**TOWN OF BROOKLYN
PLANNING AND ZONING COMMISSION
Regular Meeting Agenda
Tuesday, August 18, 2020
6:30 p.m.**

**TOWN OF BROOKLYN
PLANNING AND ZONING COMMISSION
Special Meeting
Wednesday, July 8, 2020
Clifford B. Green Meeting Center
69 South Main Street
6:30 p.m.**

DATE: 1/07/2020	DRAWN: AMR
SCALE: 1" = 40'	DESIGN: NET
SHEET: 3 OF 5	CHK BY: ---
DWG. No: CLIENT FILE	JOB No: 19129

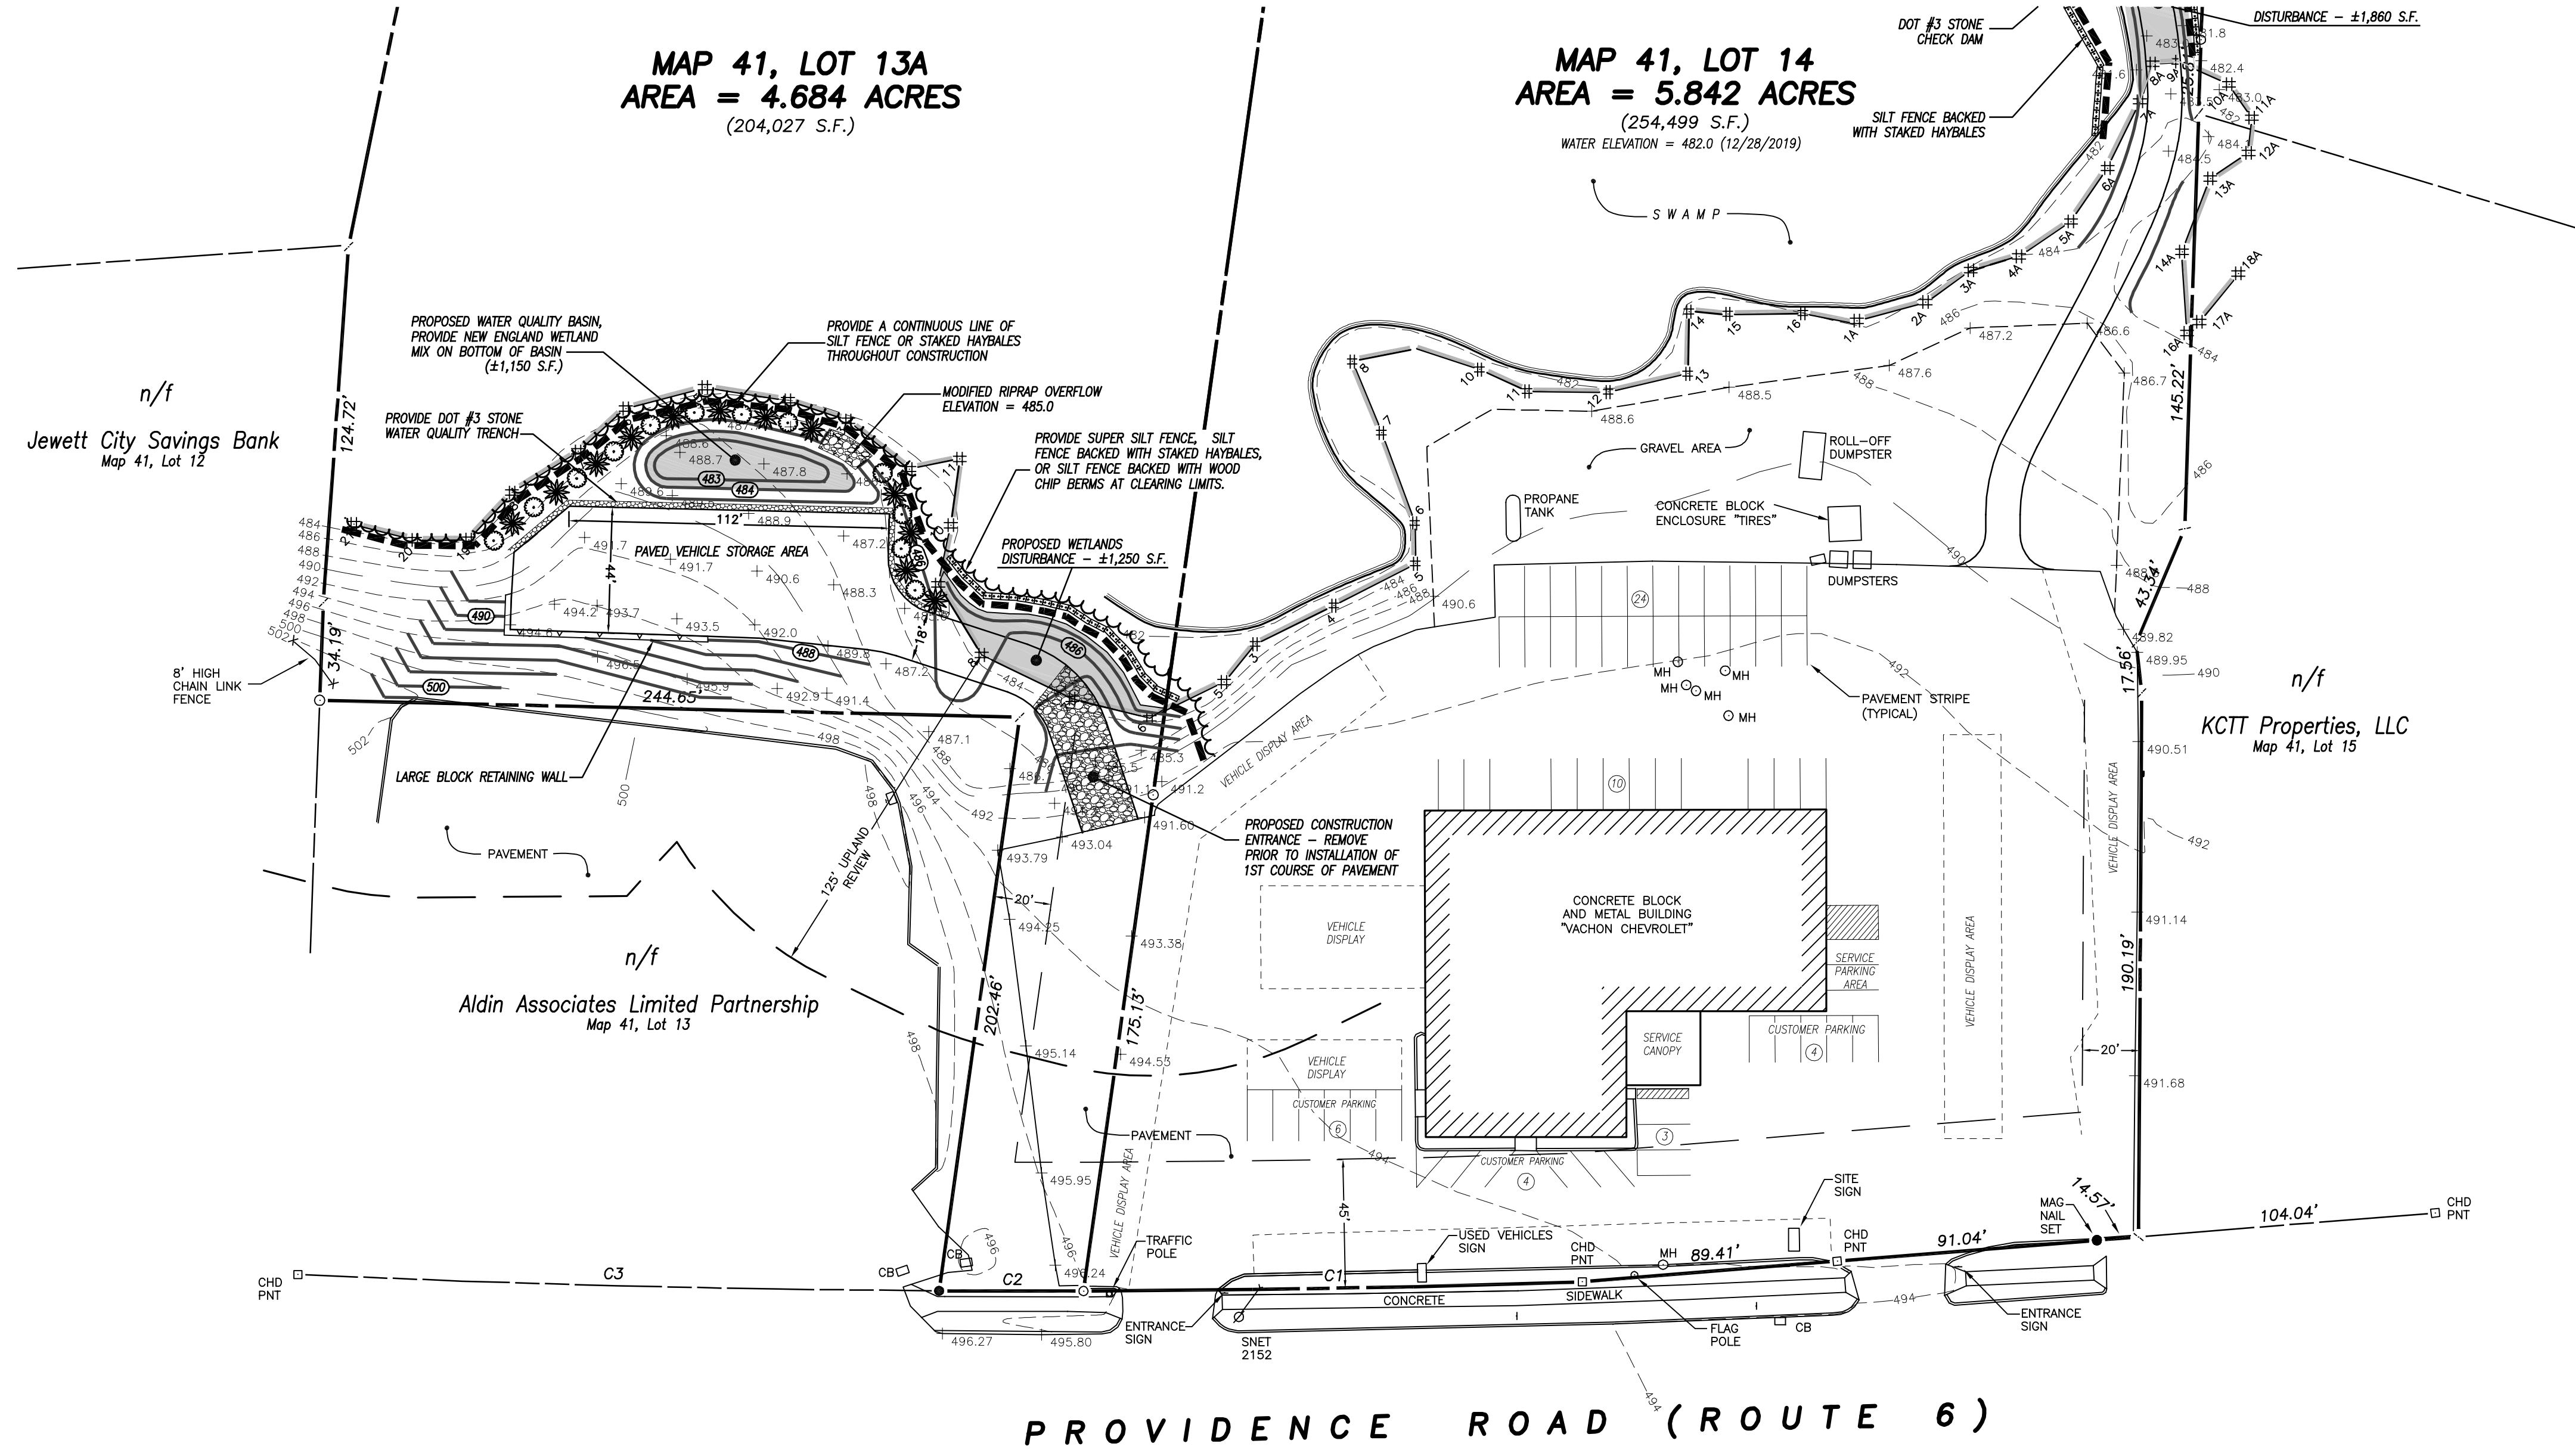
1. A construction entrance symbol is drawn at the entrance to the new "paved vehicle storage area." However, a note should be included to indicate that this will be removed at the time the first course of paving is installed for the vehicle storage area. Additionally, it would be helpful for this explanation to be included in Note 17 under "Development Schedule/Sequence of Operations" that appears on Sheet 5 of 5 of the plan set.
2. The note "Silt Fence Backed with Staked Haybales or Wood Chip Berms" should read the same as the note on Sheet 4 of 5, "Provide Super Silt Fence, Silt Fence Backed with Staked Haybales, or Silt Fence Backed with Wood Chip Berms at Clearing Limits," for consistency.

1. A note has been added to the plan to direct the contractor to remove the anti-tracking construction entrance prior to installing the first course of pavement. This has also been noted on sheet 5 of 5 in the development schedule/sequence of operations.
2. The note "silt fence backed with staked haybales or wood chip berms" has been modified to read the same on all sheets.
